SECTION 00 9115
ADDENDUM NUMBER 5

DATE: August 11, 2016

Rochester City School District
 James Monroe High School
 164 Alexander Street
 Rochester, New York
 SED #: 26-16-00-01-0-107-029
 DWT #: 26-16-00-01-7-999-019

PROJECT: **RSMP - JAMES MONROE HIGH SCHOOL**
 PHASE 2A
 DRAWING TITLE: **SECTION AT INFILL FRAME SUPPORT**
 PROJECT NO: 1522
 DRAWN BY: MR
 SCALE: AS NOTED
 ISSUE DATE: 8/10/16
 REVISION DATE:

DRAWING REFERENCE NUMBER(S): P301
DRAWING NUMBER: ADD5-SK-P-11

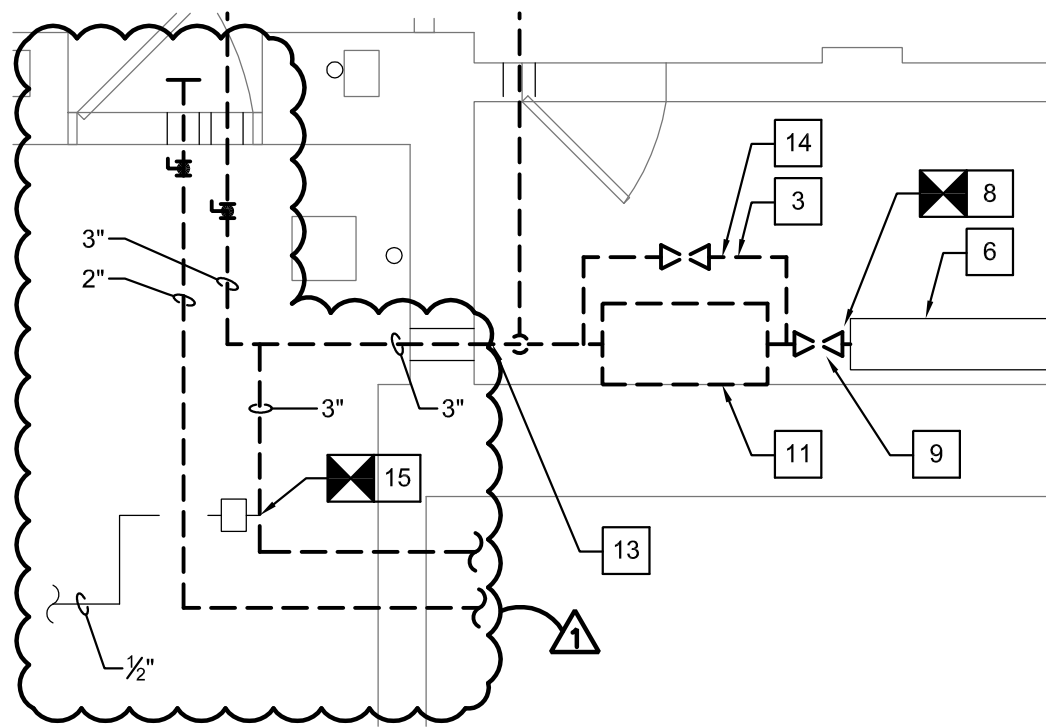
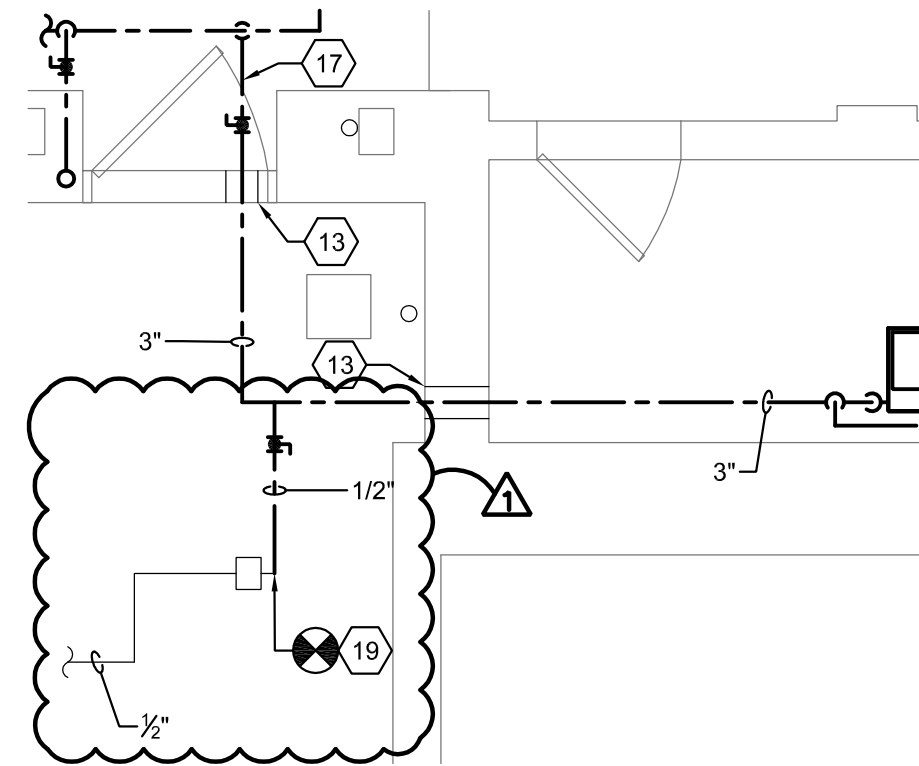
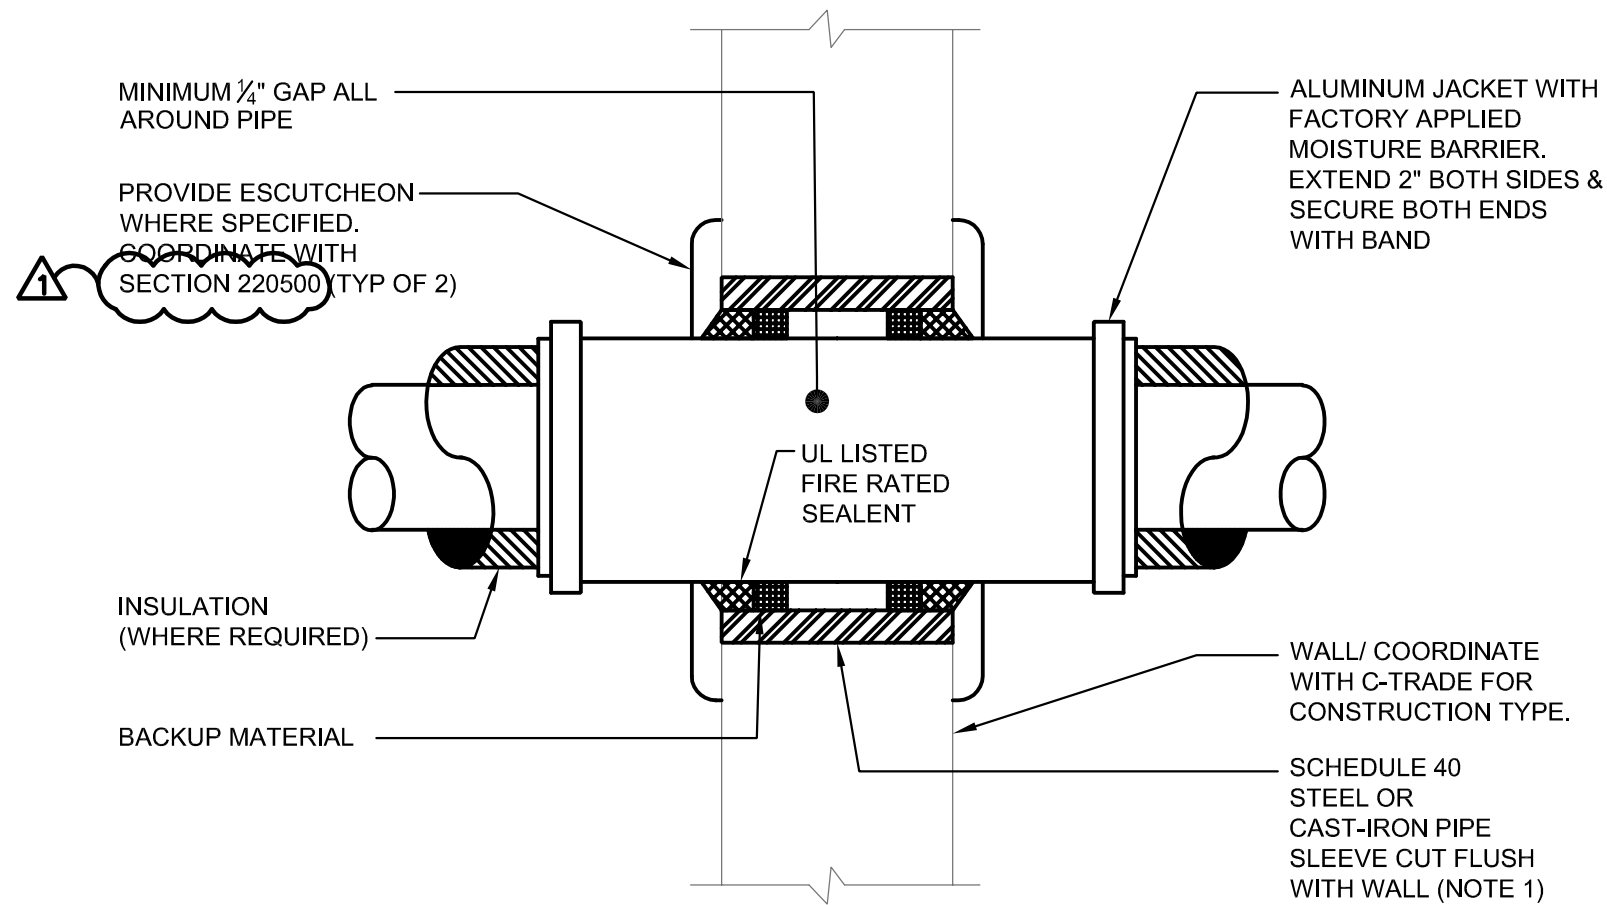
- A. Add: Connect to existing ½” C. piping with trap primer to Chemical Storage room 33. “Refer to Sketch ADD5–SK-P-11”.

- B. Add keyed notes 15 and 19. "Refer to Sketch ADD5-SK-P-11".

14. REMOVE ALL EXISTING DOMESTIC WATER PIPING INSULATION IN PUMP ROOM.
15. DISCONNECT 1/2" C. FROM 3" C. AT THIS POINT.

16. WIRE BRUSH & CLEAN EXISTING BACKFLOW DEVICE OS&Y VALVES. PROVIDE (1) ONE COAT PRIMER AND (2) TWO COATS METAL ALKYD ENAMEL FINISH PAINT (GREY).
17. PROVIDE NEW COPPER COLD WATER MAINS THROUGH WALLS TO MAINS IN CORRIDORS. COORDINATE WITH NEW CEILING, DUCTWORK, AND STRUCTURAL LOCATIONS.

DRAWING REFERENCE NUMBER(S): P500
DRAWING NUMBER: ADD5-SK-P-12

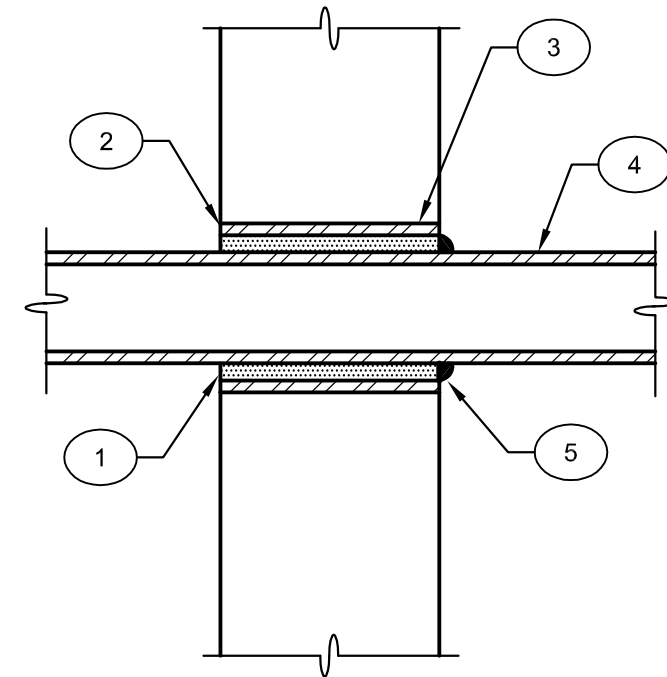
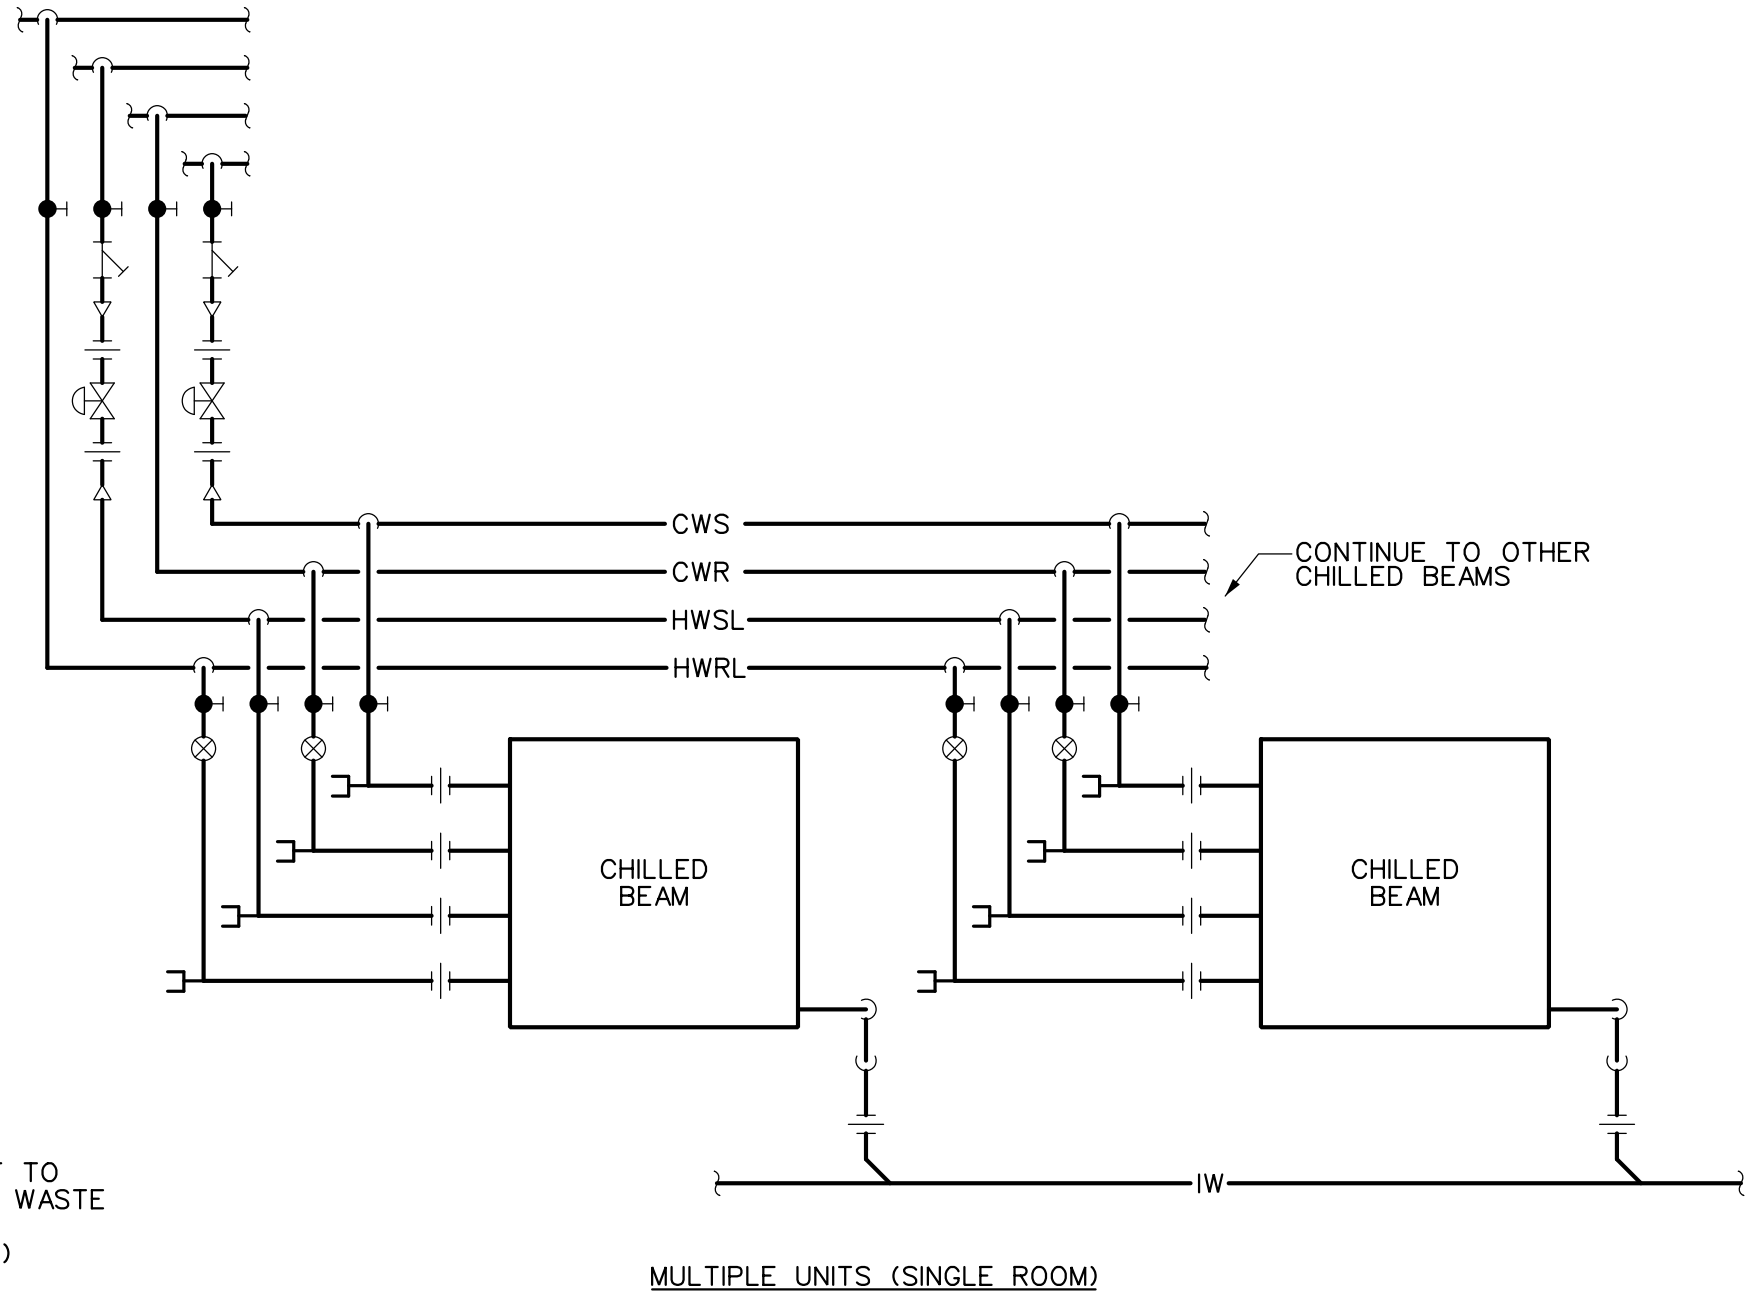
- A. Change specification number to 220500. "Refer to Sketch ADD5-SK-P-12".
- B. Edit keyed note number 3. "Refer to Sketch ADD5-SK-P-12".

CHILLED BEAM PIPING DETAIL

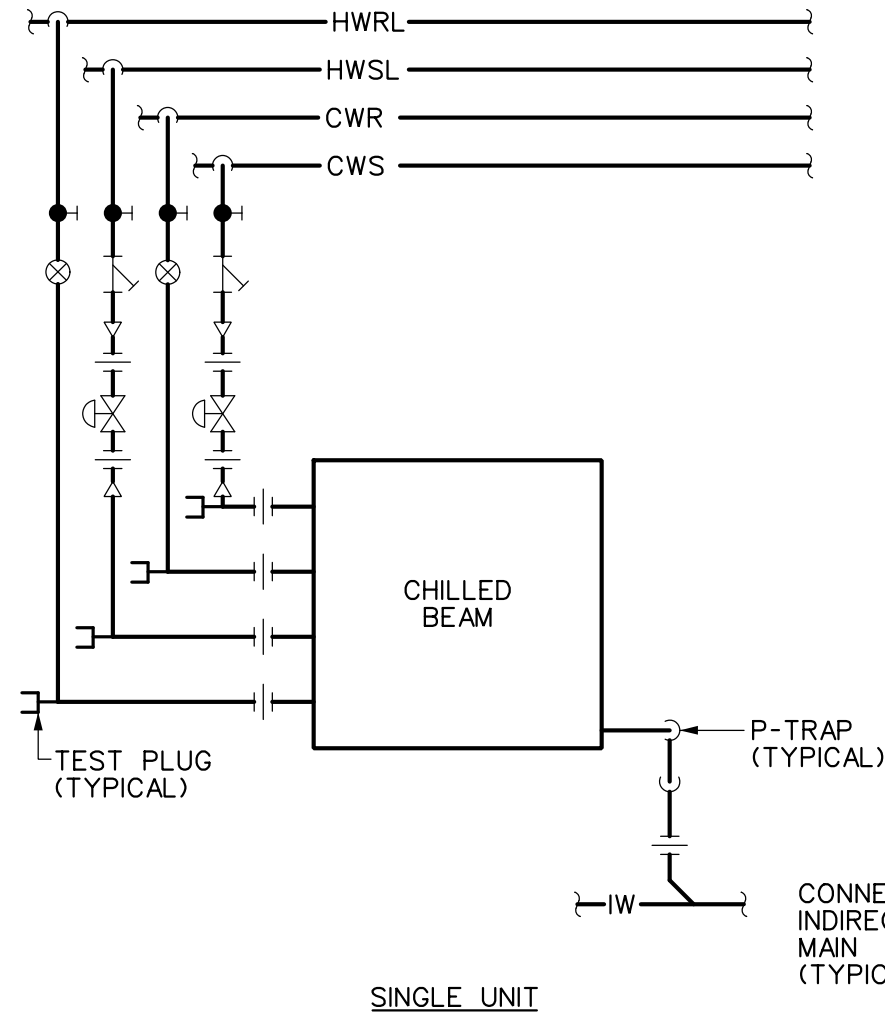
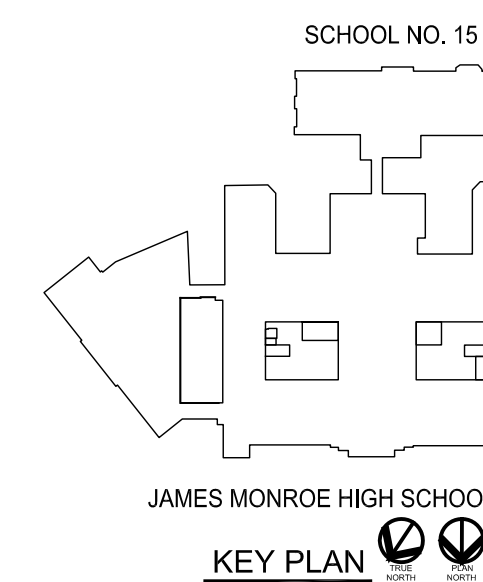
- A. Add the Chilled Beam Piping Detail as indicated on the attached sketch ADD5-M01.
